PLANNED UNIT DEVELOPMENT Date: May 7, 2009

DEVELOPMENT NAME SME Airport, LLC

LOCATION 4013 Airport Boulevard

<u>CONTEMPLATED USE</u> Planned Unit Development Approval to allow a truck unloading and trash pickup service yard in an existing parking lot in a B-2, Neighborhood Business District.

SITE PLAN

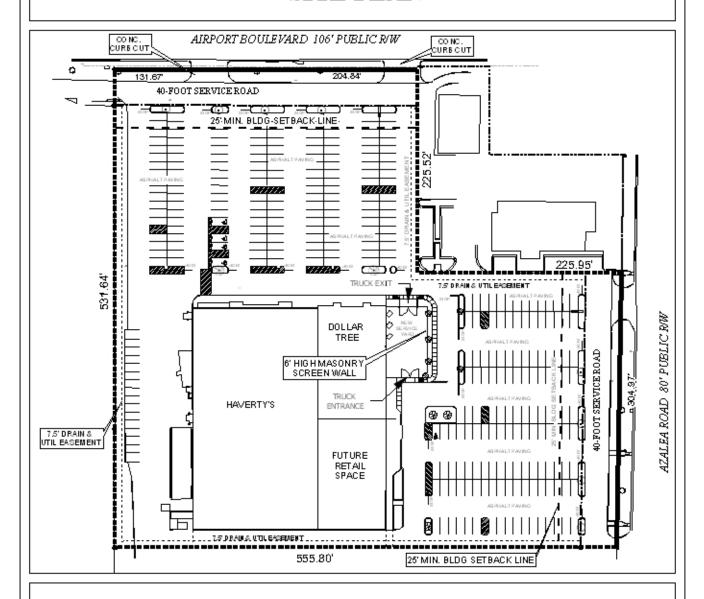
<u>COMMENTS</u> Must comply with all storm water and flood control ordinances. Any work performed in the right of way will require a right of way permit. Drainage from trash loading/unloading areas cannot discharge to storm sewer; must have connection to sanitary sewer.

Driveway number, size, location, and design to be approved by Traffic Engineering and conform to AASHTO standards. Wall height and planting should be chosen that do not block line of sight for traffic stopped next to the service area. Changes in the sight plan have created two ninety degree turns that most vehicles will be unable to negotiate. The changes also create a situation where trucks entering the service yard do so by driving in the opposing lane in the middle of the two ninety degree turns. Changes need to be made to the plan that will correct these problems.

The site plan illustrates the 53,048 square foot retail building with the proposed service yard (completely screened from view) on the Northeast corner of the structure. The applicant states that the use of the service yard will include truck unloading and trash pick up. While several parking spaces will be removed for the addition, the applicant will retain 306 parking spaces (only 177 are required).

As illustrated on the site plan, trucks will enter the service area from the South and exit to the North. This raises two concerns. First, staff is concerned about visibility, as it may be difficult for trucks to anticipate traffic circulation outside of the service area; its location will yield a rather awkward traffic flow (see site plan). Second, the proposed site plan does not appear to be pedestrian friendly, as no sidewalk is illustrated around the service area to access other retail establishments. This will require customers to either walk into traffic aisles, or they will have to drive, which defeats the purpose of an outdoor strip mall.

Nevertheless, the applicant has submitted a revised site plan addressing the concerns expressed by staff. However, while sidewalk, visibility and trees have been addressed, there is still an issue with regard to circulation. As stated by Traffic Engineering, "changes in the sight plan have created two ninety degree turns that most vehicles will be unable to negotiate. The changes also create a situation where trucks entering the service yard do so by driving in the opposing lane in the middle of the two ninety degree turns. Changes need to be made to the plan that will correct these problems."

- 1) compliance with City Engineering comments: (Must comply with all storm water and flood control ordinances. Any work performed in the right of way will require a right of way permit. Drainage from trash loading/unloading areas cannot discharge to storm sewer; must have connection to sanitary sewer);
- 2) compliance with Traffic Engineering comments: (Driveway number, size, location, and design to be approved by Traffic Engineering and conform to AASHTO standards. Wall height and planting should be chosen that do not block line of sight for traffic stopped next to the service area. Changes in the sight plan have created two ninety degree turns that most vehicles will be unable to negotiate. The changes

- also create a situation where trucks entering the service yard do so by driving in the opposing lane in the middle of the two ninety degree turns. Changes need to be made to the plan that will correct these problems); and
- 3) full compliance with all municipal codes and ordinances.
